# INDIANA DEPARTMENT OF ENVIRONMENTAL MANAGEMENT

Source Name: Riverview Energy Corporation

Permit Level: Title V – New Source Construction

## Notice of Decision: Approval - Effective Immediately

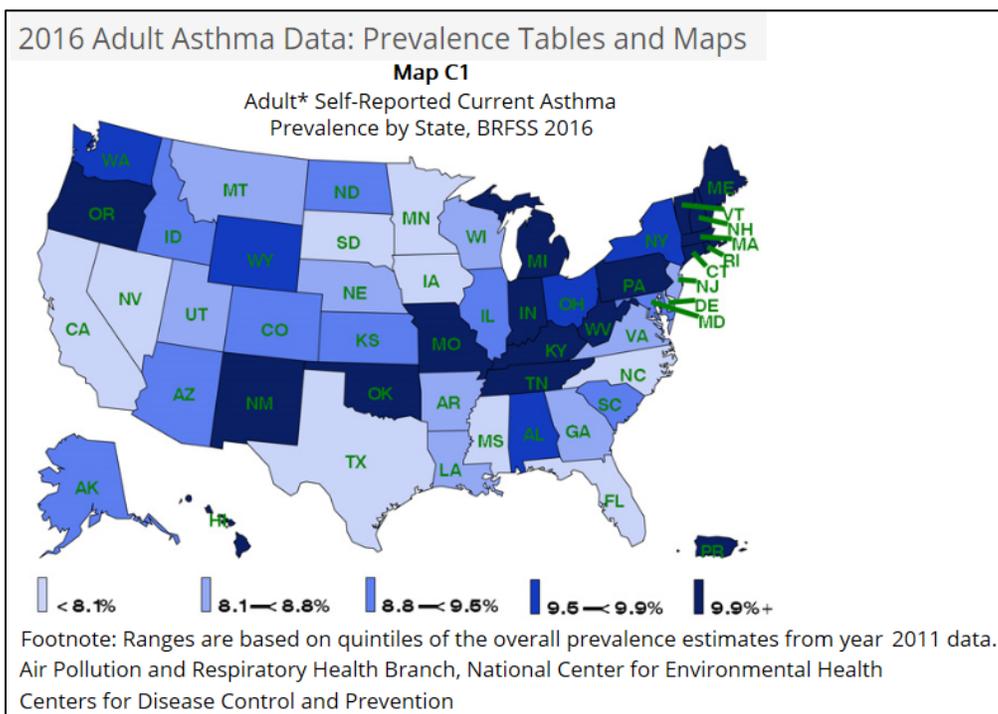
The CDC data above indicate that the 2016 adult self-reported current asthma prevalence in Indiana (10.2%) was higher than the national average (8.9%), but was similar to several other states with asthma prevalence greater than 9.9% (CT, HI, KY, MA, ME, MI, MO, NH, NM, OK, OR, PA, PR, RI, TN, VT, WV).

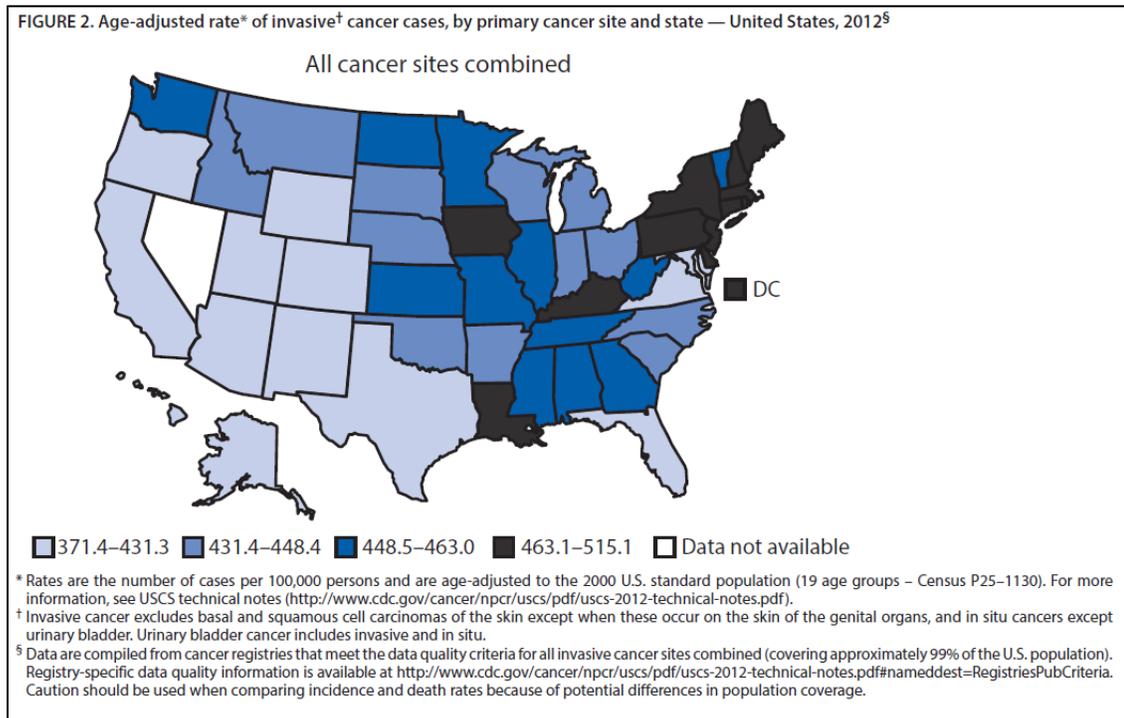
The CDC and ISDH data provided above do not support commenter claims that rates of asthma-related health effects are profoundly higher in all counties in southwest Indiana as compared to the rates in Indiana (state-wide), the Midwest, or the nation. For most counties in southwest Indiana, rates of asthma-related health effects are lower or not statistically different than the Indiana (state-wide) rates.

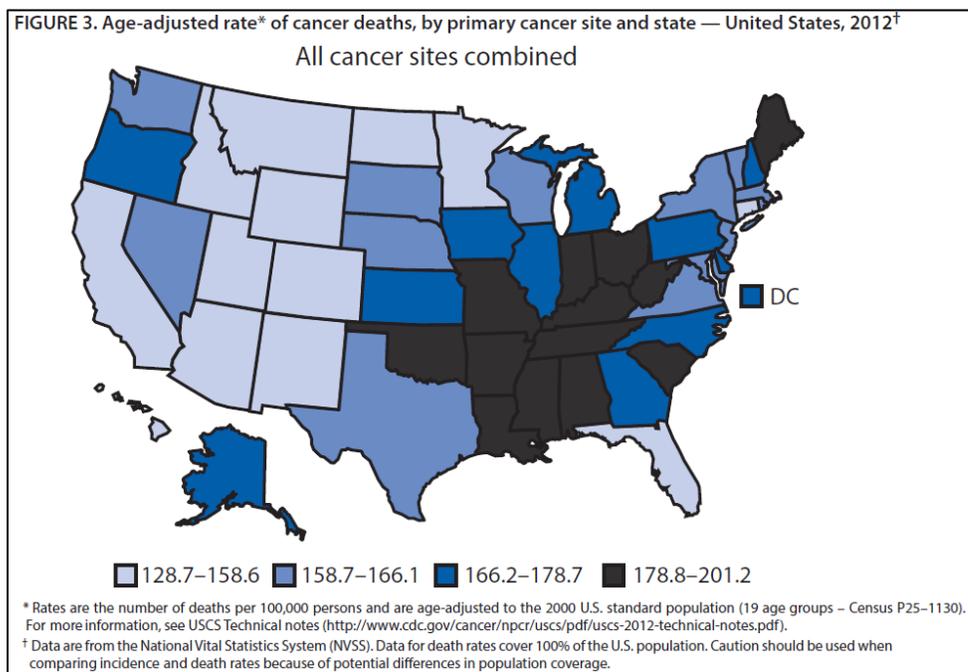
The CDC data above indicate that the 2012 cancer incidence rate (invasive cancer cases) in Indiana (439.4 per 100,000 persons) was similar to the overall national rate (440.3 per 100,000 persons).

The CDC data above indicate that the number of 2012 cancer deaths in Indiana (184.2 per 100,000 persons) was higher than the overall national rate (166.4 per 100,000 persons), but was similar to several other states with cancer incidence rates between 178.8 and 201.2 per 100,000 persons (AL, AR, IN, KY, LA, MO, MS, OH, OK, SC, TN, WV).

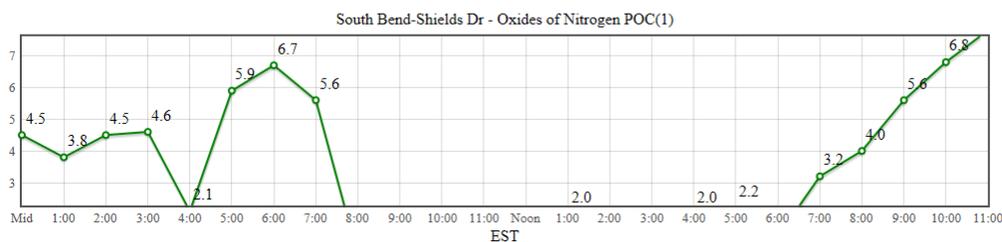
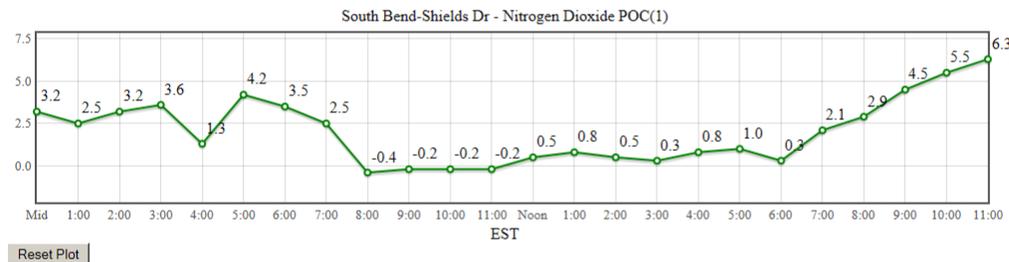
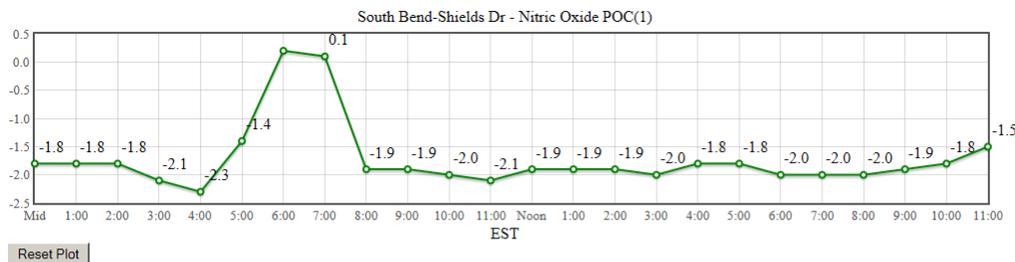
On July 15, 2017, the daily average concentration for NO<sub>2</sub> in South Bend comes out to be 2.02 ppb because of the lowering effect of the negative values. For the same day in Evansville, the corresponding daily average concentration was 5.91 ppb, that is, almost 3 times higher. Now, based on the South Bend data, the NAAQS analysis showed a rather narrow gap (only 47.72  $\mu\text{g}/\text{m}^3$ ) from "NAAQS VIOLATION":

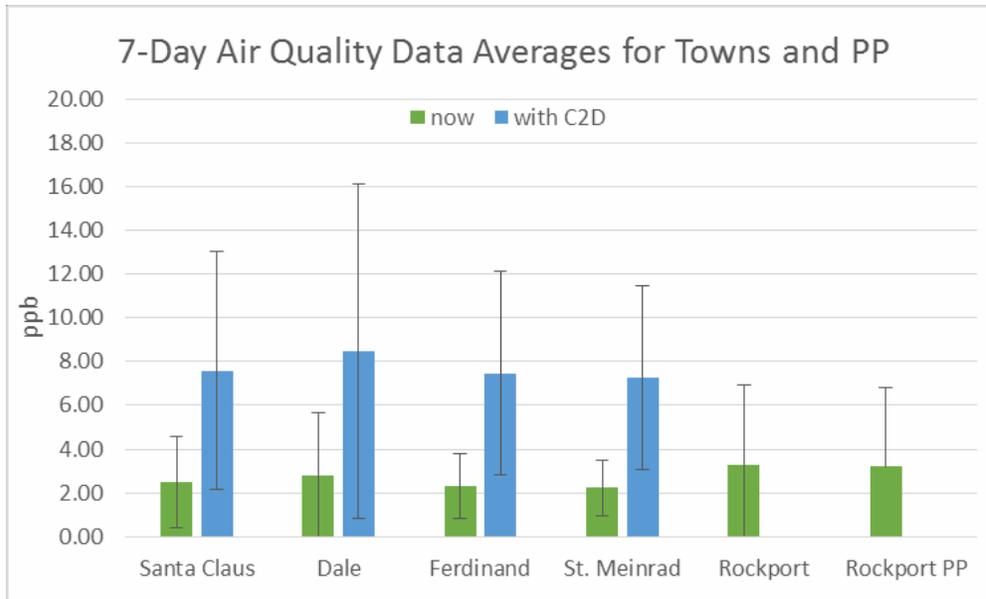
- 6) Between June 14 and June 21, 2018, I monitored the air quality through the BreezoMeter web site at 6 different location: Santa Claus, Dale, Ferdinand, St. Meinrad, Rockport, and the Rockport Power Plant (PP). The 7-day averages looked like this:

One could only wish that similar monitoring of the proposed REC plant and key nearby locations (school, nursing home) had been conducted by IDEM officials. Having seen the result of the NAAQS Analysis in the draft air permit, I can make the following predictions for the impact on the 3-hour SO2 concentrations in Dale and nearby towns, by adding a 350% increase to the levels observed in June, 2018:

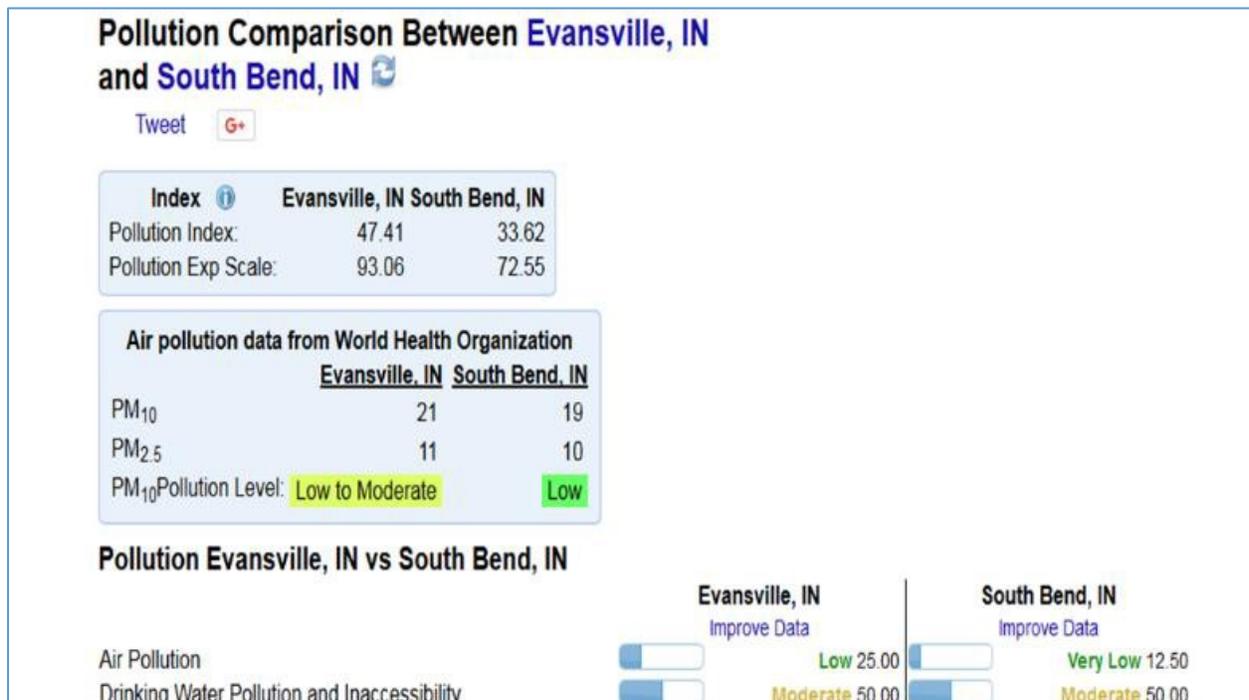
7) Modeling air quality in Dale using data from South Bend or Evansville cannot be expected to provide reliable results according to other comparative sources. For instance, Numbeo.com says that air pollution in Evansville is about twice as high than in South Bend -- 25 vs. 12.5 ([https://www.numbeo.com/pollution/compare\\_cities.jsp?country1=United+States&country2=United+States&city1=Evansville%2C+IN&city2=South+Bend%2C+IN&tracking=getDispatchComparison](https://www.numbeo.com/pollution/compare_cities.jsp?country1=United+States&country2=United+States&city1=Evansville%2C+IN&city2=South+Bend%2C+IN&tracking=getDispatchComparison)):

Several data points taken in a one-day period (12/6/18-12/7/18) using BreezoMeter.com show an average NO<sub>2</sub> concentration of 4.84±2.36 ppb, 11.09±5.10 ppb, and 8.86±3.49 ppb for South Bend, Evansville, and Dale, respectively. The differences do not seem to be negligible.
